Technical Bulletin

Remove Line Voltage from Terminal Block When Installing Electric Heat Kit

Document #: TB-FLX-11102022

Reference: Installation of FLEXX Electric Heat Kit

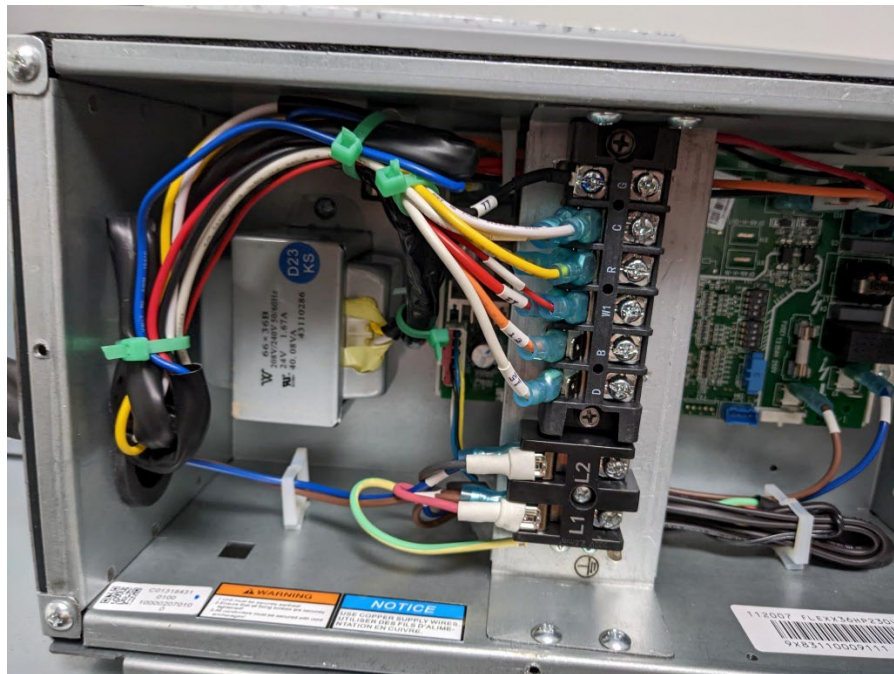
Instances of high voltage electrical shorts have been reported with FLEXX air handlers with electric heat kits installed. This can lead to damage to the unit or personal injury. Most commonly, damaged moxex connectors have been reported.

When installing an electric heat kit in a FLEXX air handler, line voltage must only be connected to the circuit breakers included with the heat kit. Line voltage must be disconnected permanently from L1 and L2 on the terminal block. If line voltage is connected to the electric heat kit circuit breakers and the terminal block at the same time, a high voltage short will occur.

Disconnect line voltage from L1 and L2 permanently before installing an electric heat kit to prevent a high voltage short.
